This supplementary instruction manual contains only the steps specific to the LAZER ZX-RR assembly. Use it together with the LAZER ZX-R instruction manual.

- 7** • The slipper clutch changed.
Use Bag No.4

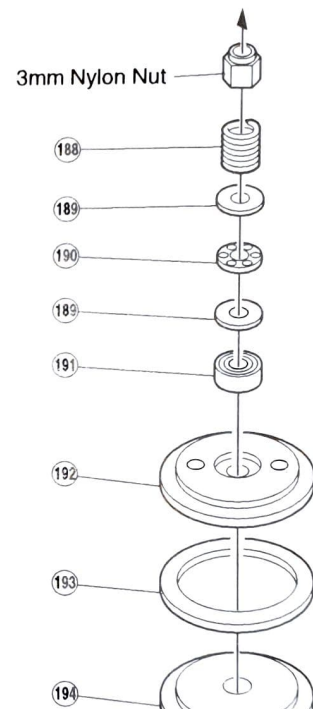
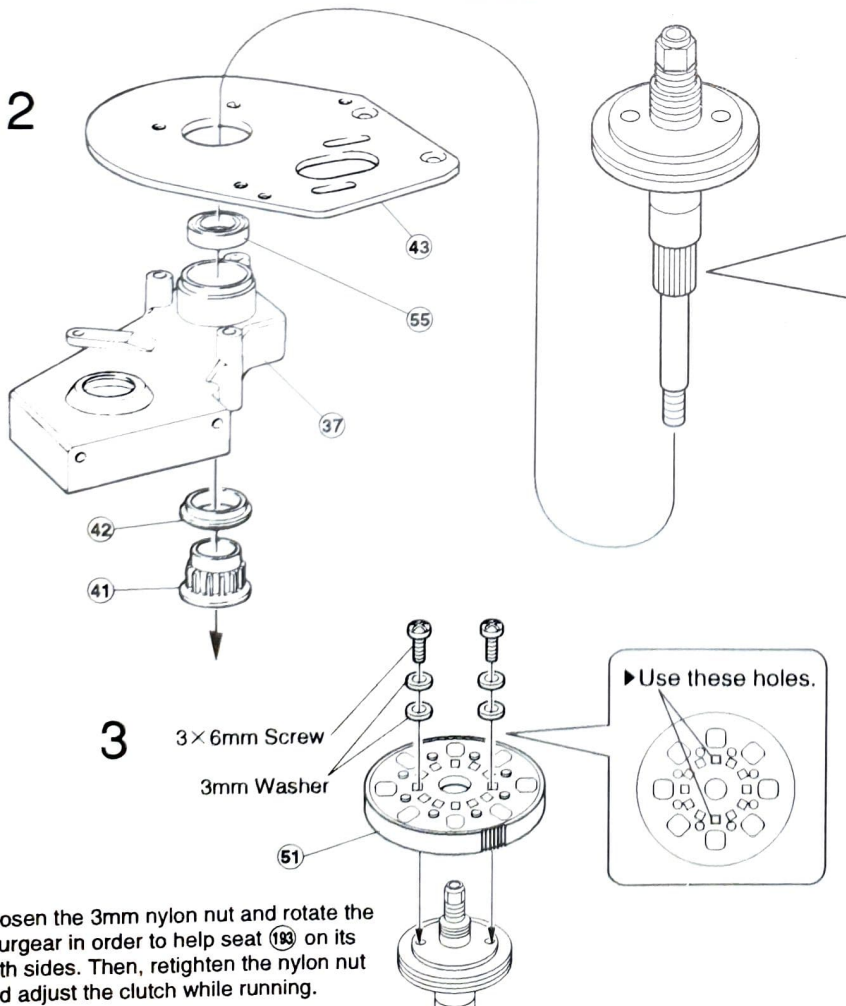
▶ Loosen the 3mm nylon nut and rotate the spur gear in order to help seat (193) on its both sides. Then, retighten the nylon nut and adjust the clutch while running.

▶ First, install (148).

▶ Slide (196) up to (148) and tighten set screw to the flat spot.

8 • Instead of ①④⑥ 4×6mm shim, ①⑨⑦ is used. Use Bag No.4

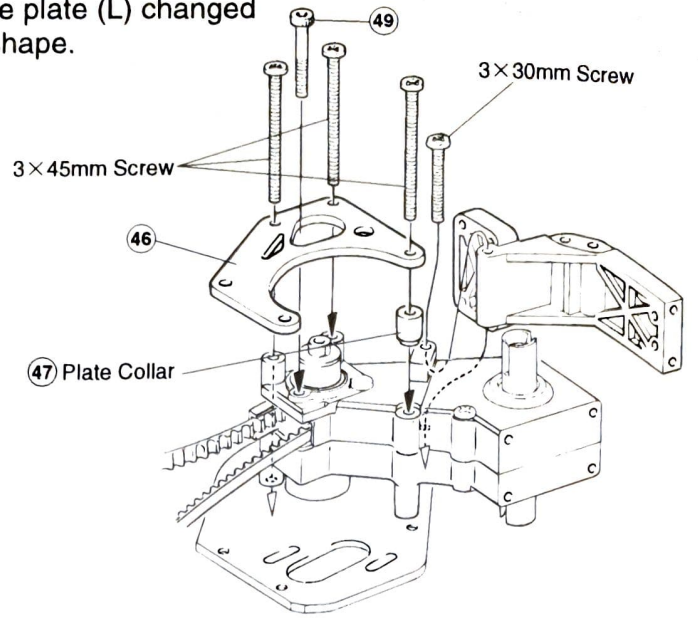
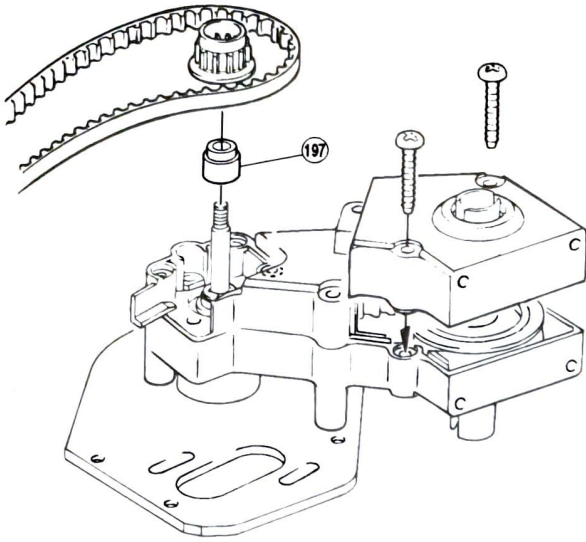
• ④⑥ Side plate (L) changed in shape.

11 • The stopper posts changed. • Attaching ④⑥ changed. Use Bag No.6

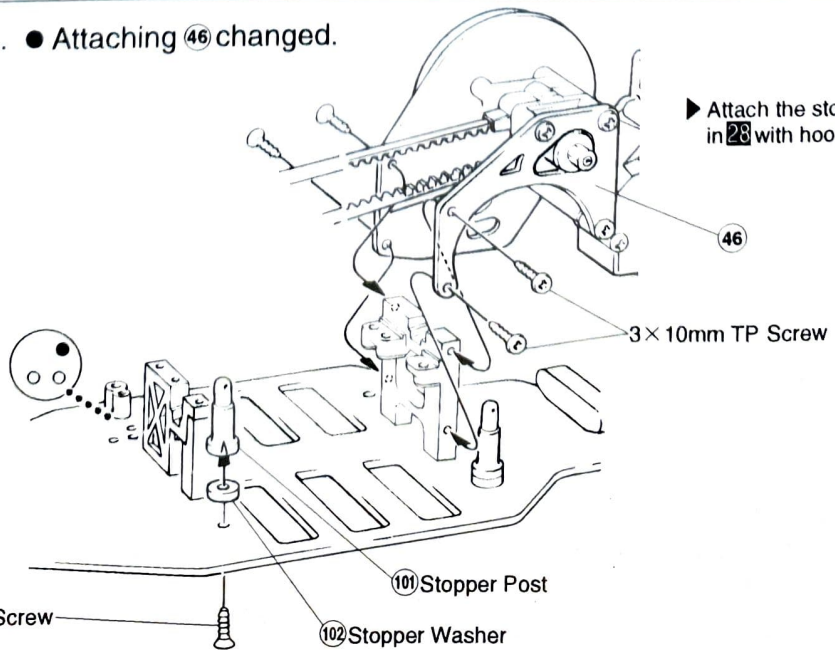
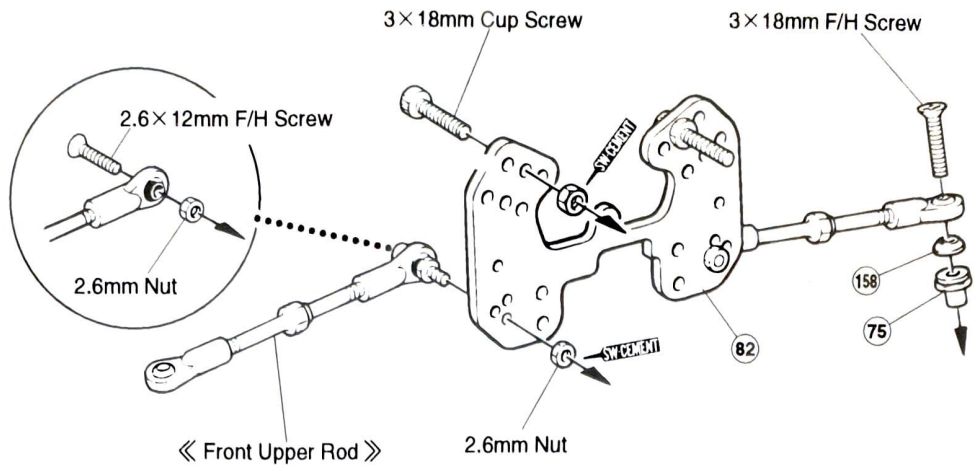
▶ Attach the stopper plates in ②③ with hook pins.

13 • Attaching the knuckle arms changed.
Use Bag No.5,6

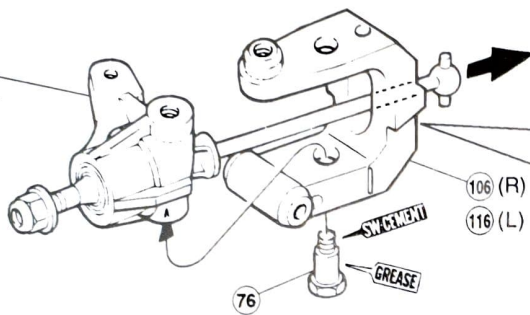
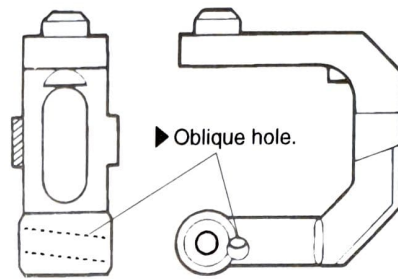
► "R" = left.
"L" = right.

► Cut off the shaded portion.

14 • Attaching the suspension arms changed.

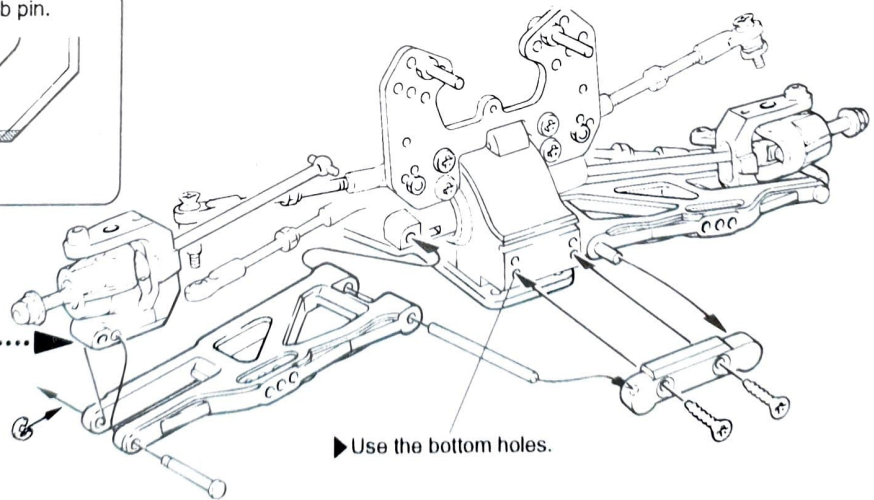
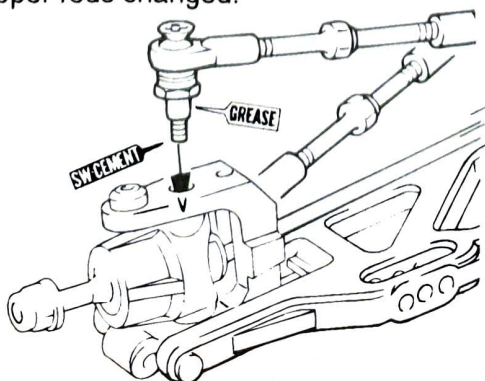
► Hole for passing through hub pin.

► Trim off the shaded portion.

16 • The rear shock stay changed in shape.

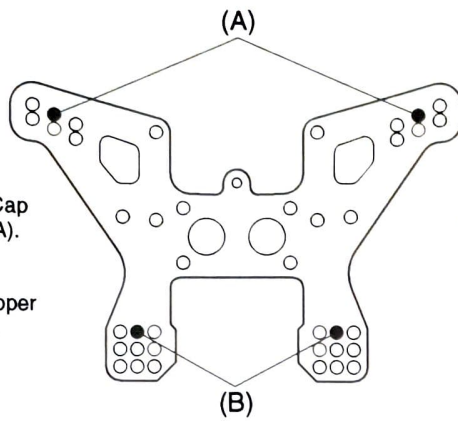
• Trim the wing stay (B) as shown.

▶ Install 3×18mm Cap Screws to holes (A).

▶ Install the Rear Upper Rods to holes (B).

▶ Cut off the shaded portion.

17 • Rear hub plates have been added.

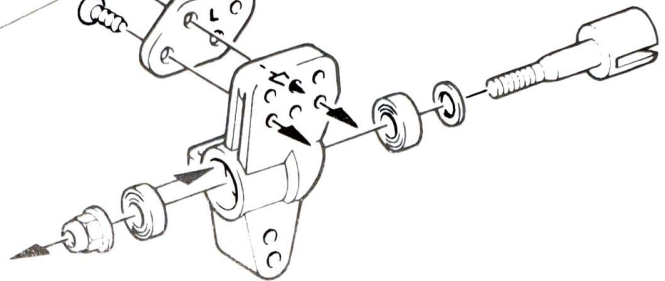
▶ Hole for attaching the rear upper rod (see 18).

20 • Attaching the motor changed.
Use Bag No.8

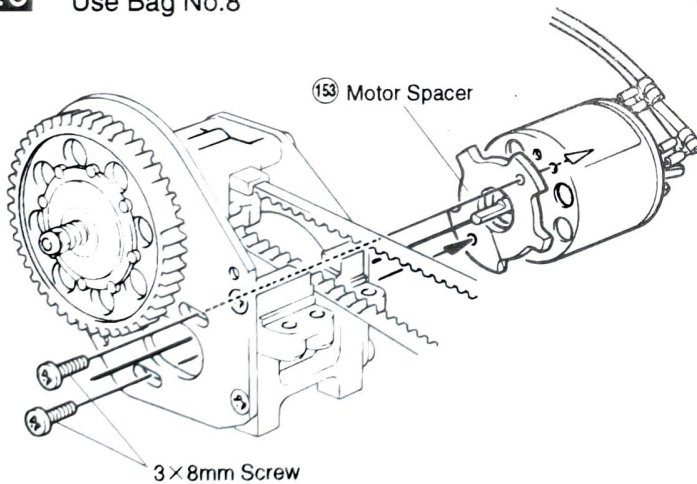
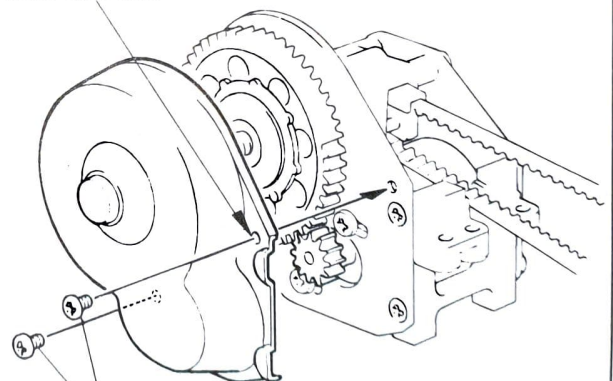
▶ Make 3mm hole.

30 ● Inner sponges have been added.
Use Bag No.8

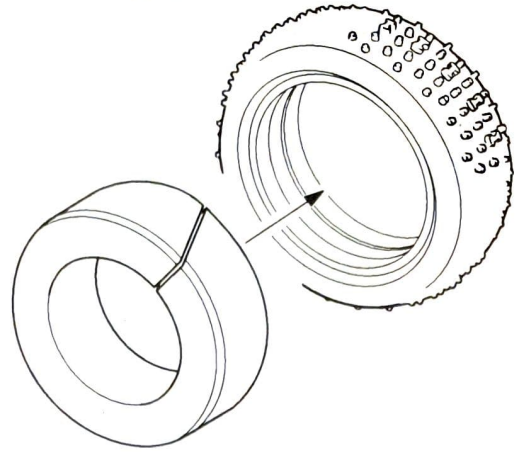
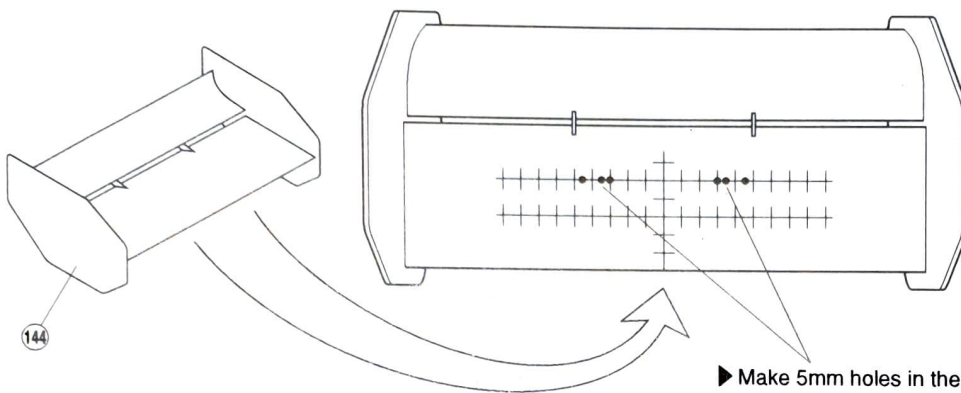
▶ Clean the tires with a neutral detergent.
Roughen the tires where glued onto the wheels.
